State of Idaho

Department of Water Resources

Date: February 3, 2016

Subject: Review of Hydrologic Data Analyses Submitted by RMEA in Support of Application for Transfer 80496

Figure 2 - Spring Slough PODs in Vicinity of Boyd Smith Well

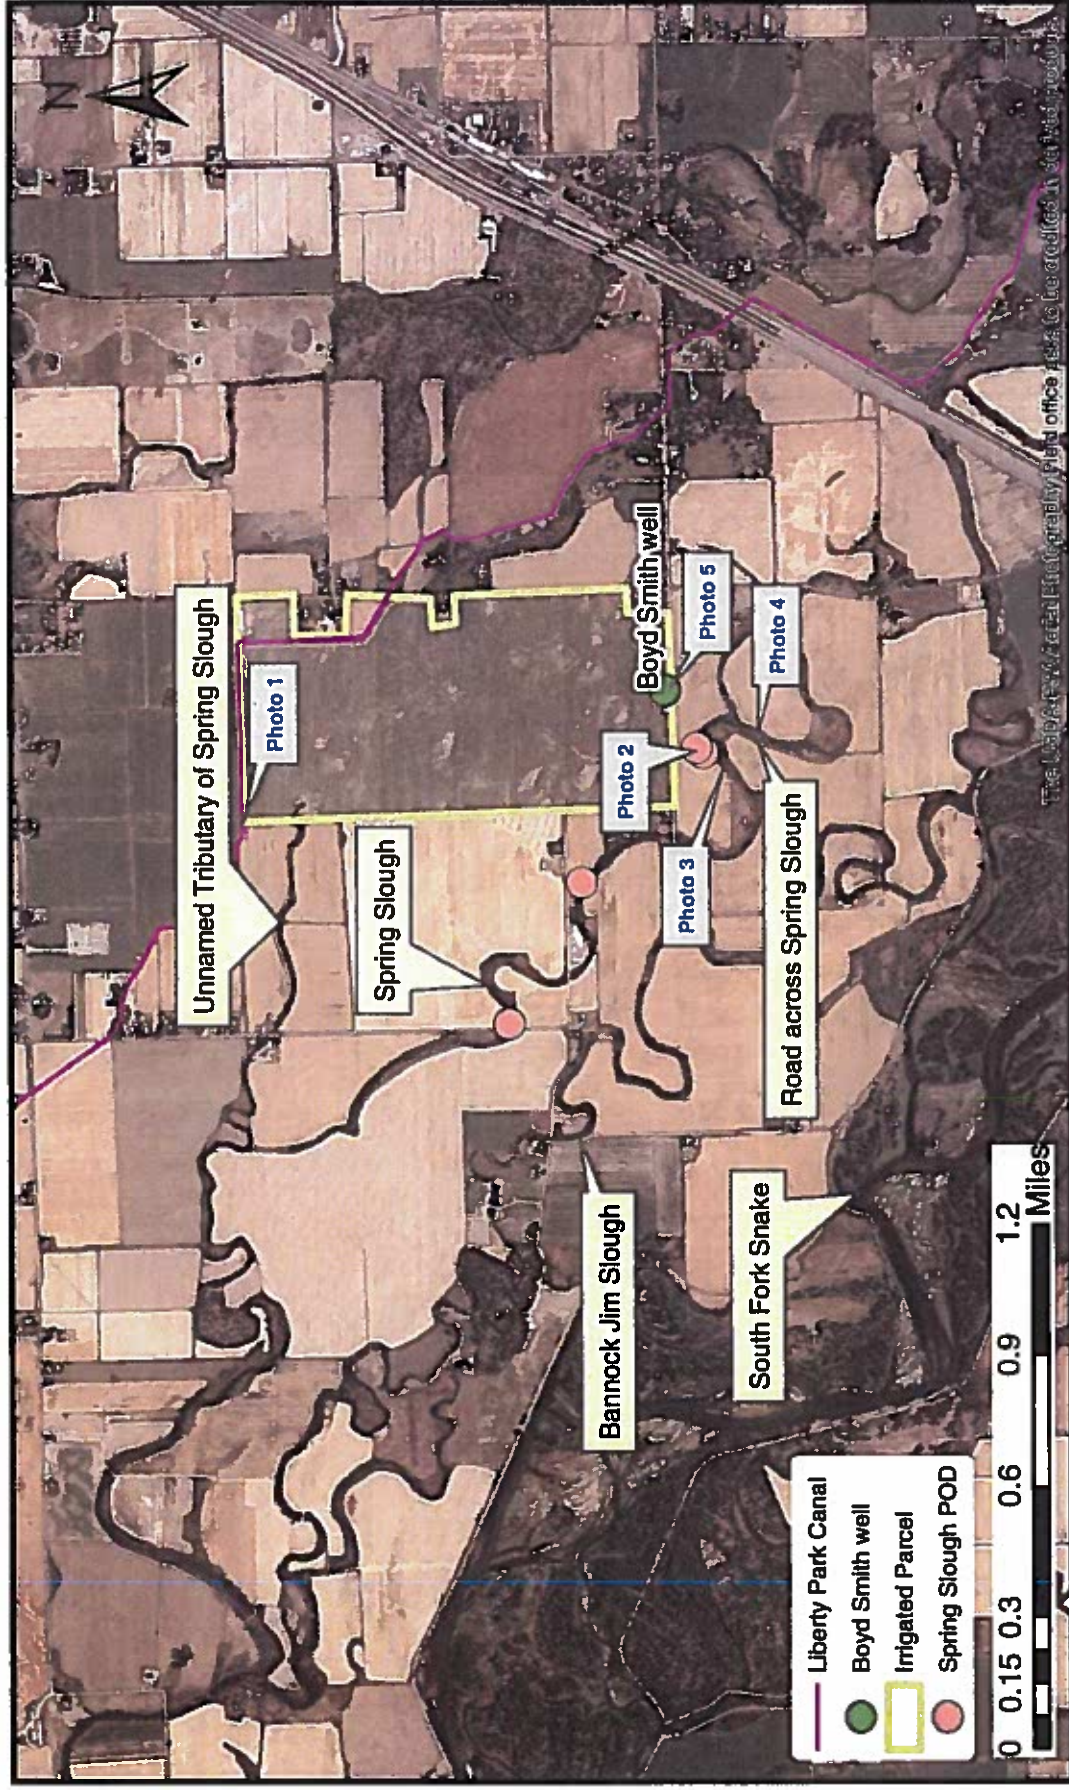
Spring Slough is located between the proposed POD and the main channel of the South Fork (see Figure 2 in Attachment A). The slough channel bifurcates approximately 0.1 miles upstream (southeast) from the point on the slough closest to the proposed POD. The furthest point upstream on the main channel abuts irrigated cropland that is approximately 0.75 miles upstream (southeast) of the proposed POD.

The nearest open channel connection between Liberty Park Canal and Spring Slough is via an unnamed tributary that intersects Spring Slough approximately two river miles downstream (northwest) of the proposed POD (see Figure 2 in Attachment A). During a site visit on December 9, 2015, I verified the existence of a ditch located along the west side of the irrigated parcel that could be used to route water from Liberty Park Canal into the unnamed tributary (see Photo 1 in Attachment B). The connecting ditch is approximately 620 feet long.

There are two pumping stations on the slough at the approximate location closest to the Boyd Smith well (see Photo 2 in Attachment B). These diversions do not have IDWR identification tags but are used to irrigate lands adjacent the slough. Immediately downstream from that location, the water in the slough was approximately six inches deep during the site visit (see Photo 3 in Attachment B). Further downstream, there are two more on-slough diversions in the IDWR spatial database. These diversions are located upstream (southeast) of the confluence with the unnamed tributary to Spring Slough.

- 8) The two PODs on Spring Slough that are nearest the Boyd Smith well do not have identification tags and are not in the IDWR spatial database. It is unclear whether there are water rights for these diversions.
